ADDENDUM NO. 4

INDIANA STATE FAIR COMMISSION RENOVATION TO DISCOVERY HALL PHASE III

**INDIANA STATE FAIR COMMISSION
RENOVATIONS TO GIRLS DORMITORY PHASE II
DISCOVERY HALL RENOVATION PHASE III**

PROJECT NO. 04057

DRAWING NO: **ADD.4-M1**

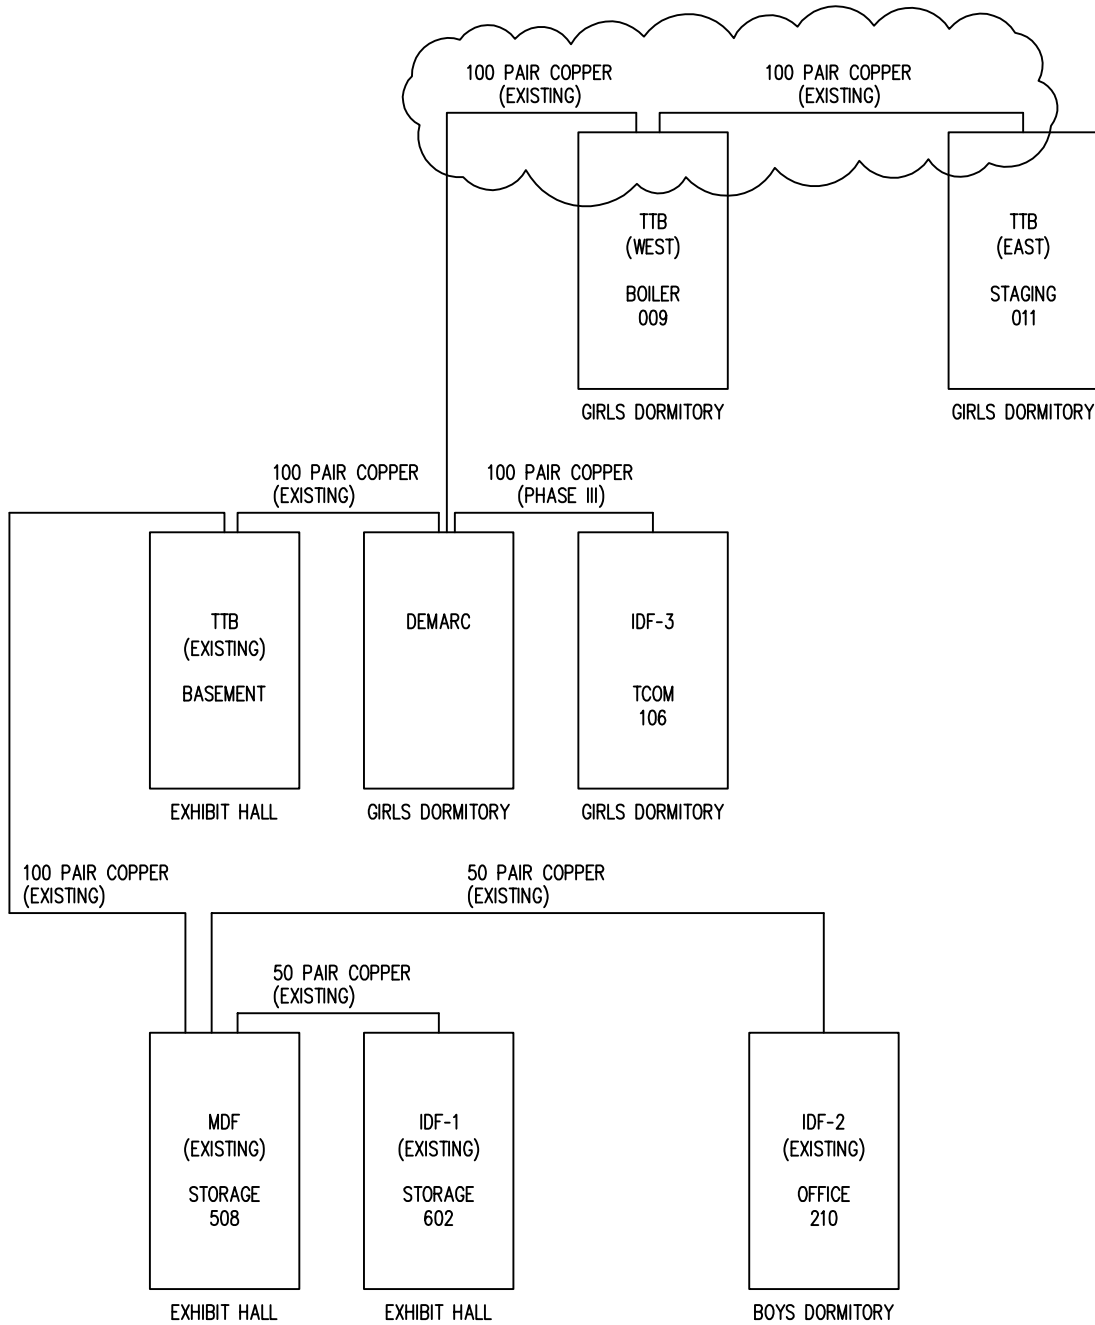
- B. Add Chiller Schedule per attached Drawing ADD.4-M1.
 - C. Electric Unit & Wall Heater Schedule: Clarification, EUH-8 shall be installed as part of Phase III.

DRAWING NO: **ADD.4-E1**

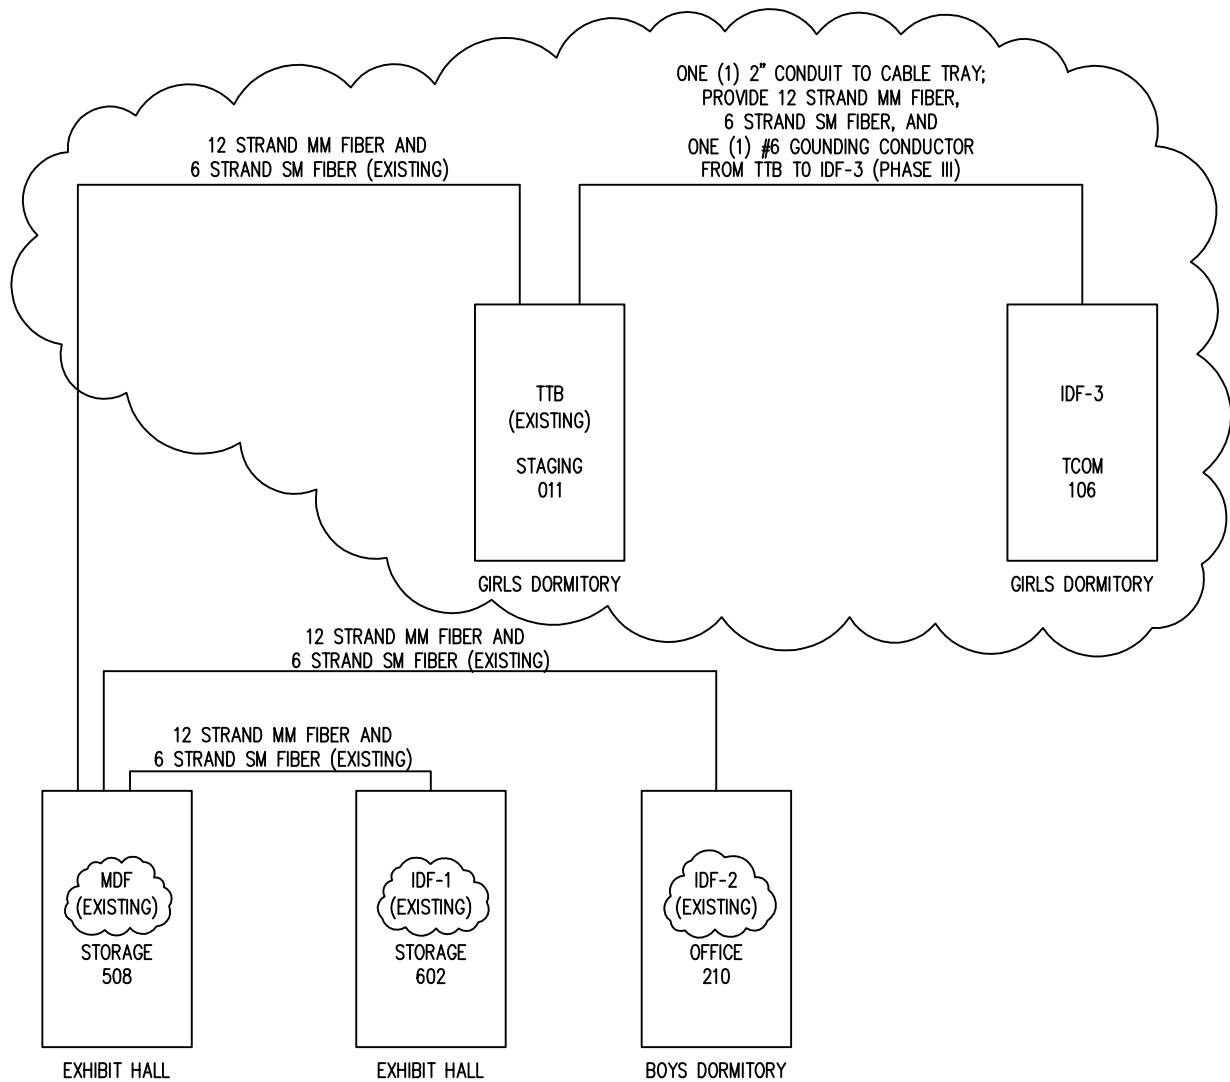
- B. Detail 3: Revise per attached Drawing ADD.4-E1.
 - C. Detail 4: Revise per attached Drawing ADD.4-E2.
19. Drawing E502 – Electrical Details
 - A. Detail 6: Replace this detail with the attached Drawing ADD.4-E3.
